**SOLICITATION AMENDMENT
MODIFICATION DE L'INVITATION**

Title - Sujet Agrandissement quai des traversiers	
Solicitation No. - N° de l'invitation EE519-220842/A	Amendment No. - N° modif. 005
Client Reference No. - N° de référence du client R.115132.100	Date 2021-10-26
GETS Reference No. - N° de référence de SEAG PW-\$QCM-032-18217	
File No. - N° de dossier QCM-1-44065 (032)	CCC No./N° CCC - FMS No./N° VME
Solicitation Closes - L'invitation prend fin at - à 02:00 PM Eastern Daylight Saving Time EDT on - le 2021-11-02 Heure Avancée de l'Est HAE	
F.O.B. - F.A.B.	
Plant-Usine: <input type="checkbox"/> Destination: <input checked="" type="checkbox"/> Other-Autre: <input type="checkbox"/>	
Address Enquiries to: - Adresser toutes questions à: Girard, Isabelle	Buyer Id - Id de l'acheteur qcm032
Telephone No. - N° de téléphone (418) 580-3551 ()	FAX No. - N° de FAX () -
Destination - of Goods, Services, and Construction: Destination - des biens, services et construction:

AMENDMENT-005

Wharf Extension, Reinforcement, and New fenders Cap-aux-Meules, Québec

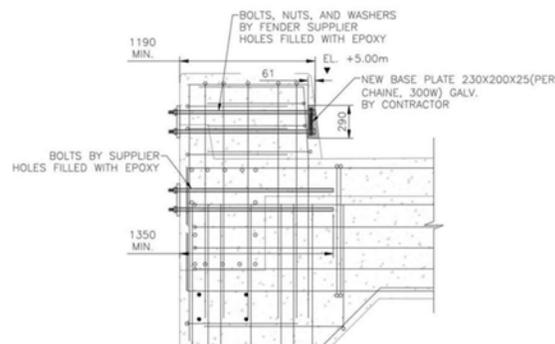
Question 29 : The answer to question 12 contradicts the information on the drawings, which information takes precedence?

Answer 29 : For the underside anchors shown on the drawing, the plates will be provided by the supplier as on the drawings. For the upper chain anchors, given they require drilling through existing concrete, we recommend, at this stage, to provide for each fender either a 1020x235x30mm back plate or two 230x200x25mm to install in a recess to execute into the existing concrete.

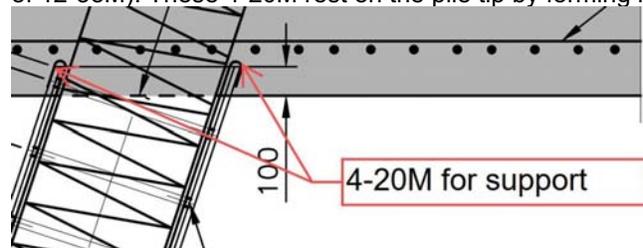
Question 34 : On drawing C21, Typical Detail – Pile Connection, there is a callout for 4-20M, however in section A next to that it shows 12-35M. Should those callouts match? Or is there a transition from 4-20M to 12-35M that I am not seeing a detail for?

Answer 34 : The 4-20M are construction supports forming a basket to hold the rebar cage up (itself constituted of 12-35M). These 4-20M rest on the pile tip by forming hooks:

#24

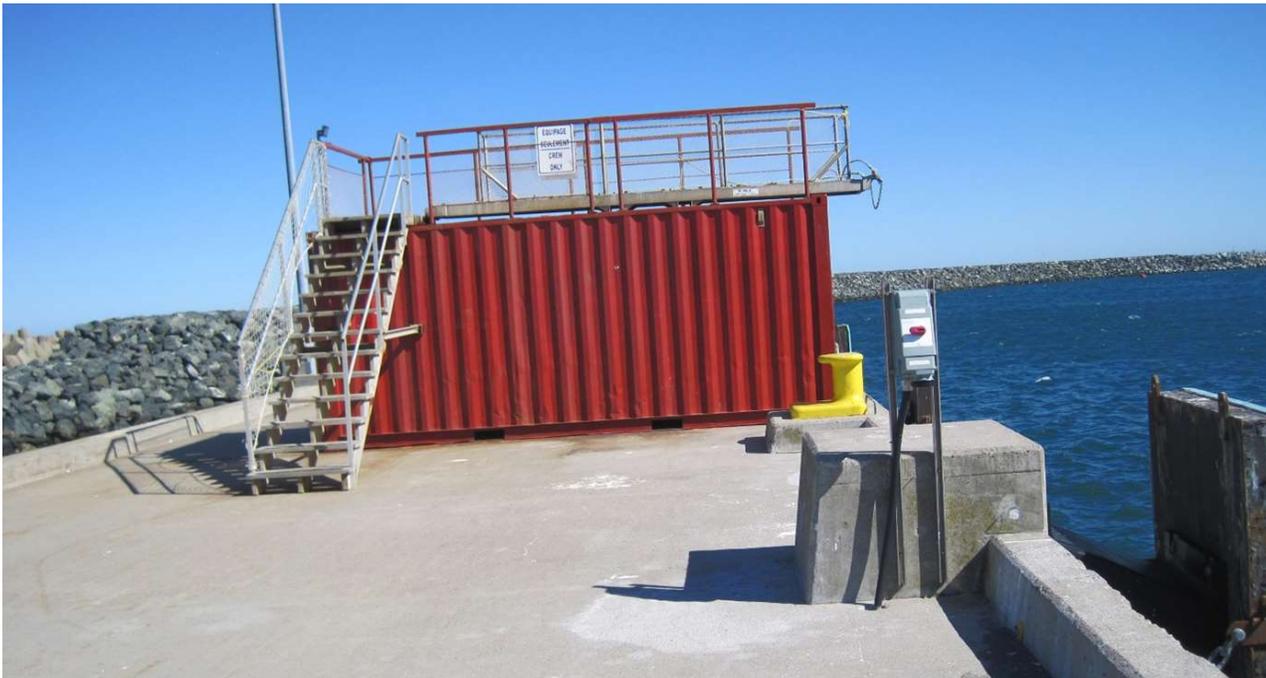
Question 24 : In specification section 02 41 99 item 3.2, it is mentioned “ The Departmental Representative shall designate the location from which the contractor must obtain drinking water. « Is it possible to have the location of this source, the flow rate, the output size and is it possible to use this source during the whole duration of the works?

Answer 24 : Ferry water intake is on the wharf, use to coordinate with CTMA, ferry operator; see attached picture.

#25

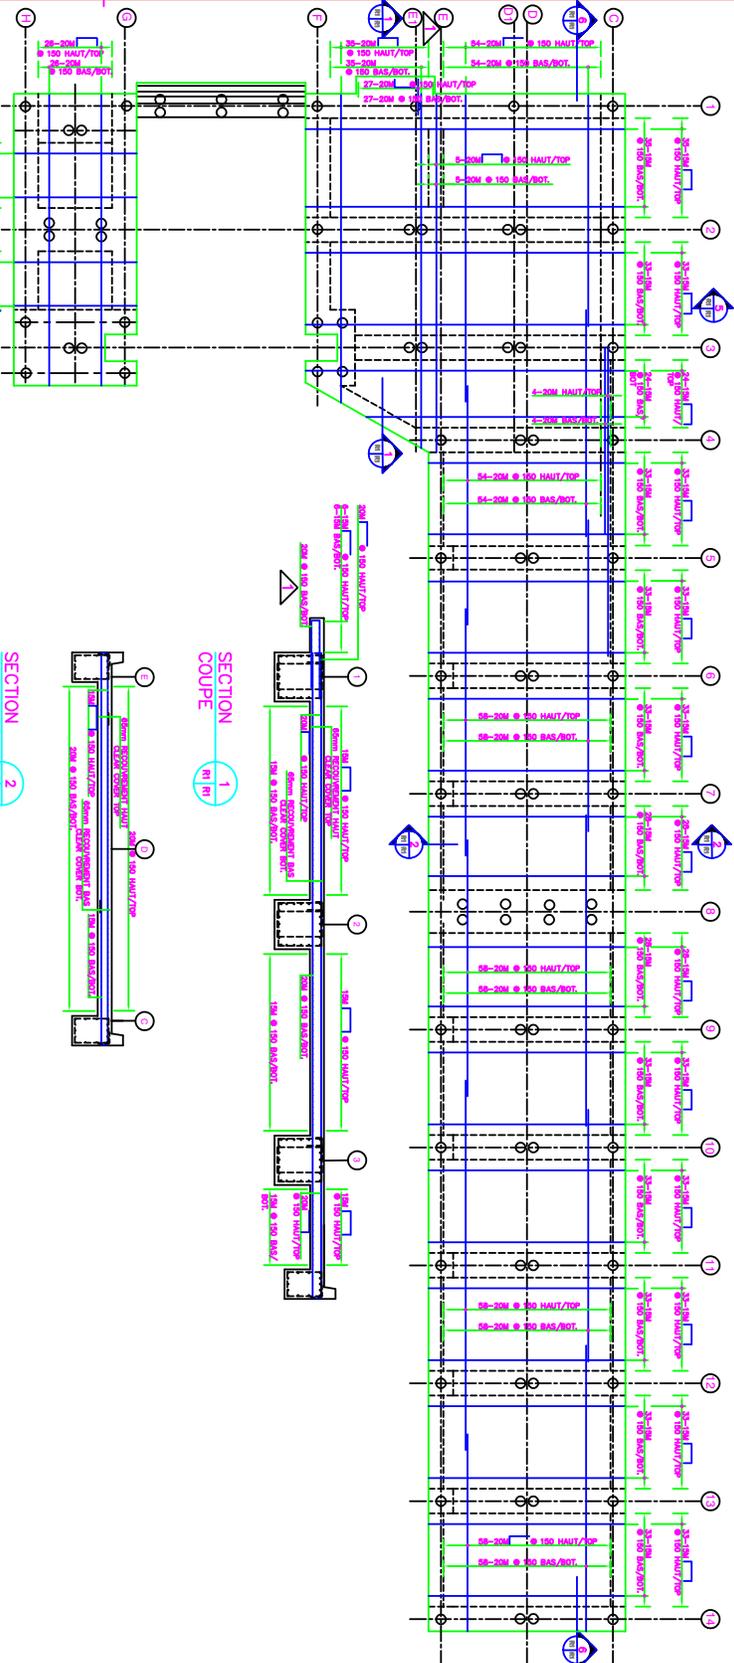
Question 25 : Is it possible to move the container and the stairs located between axis 19 and 22 in drawing C04, if so what is the its weight?

Answer 25 : It is possible. The procedure will have to be submitted to the Departmental Representative. Consider the 20 feet container is empty (2230kg). See attached pictures.
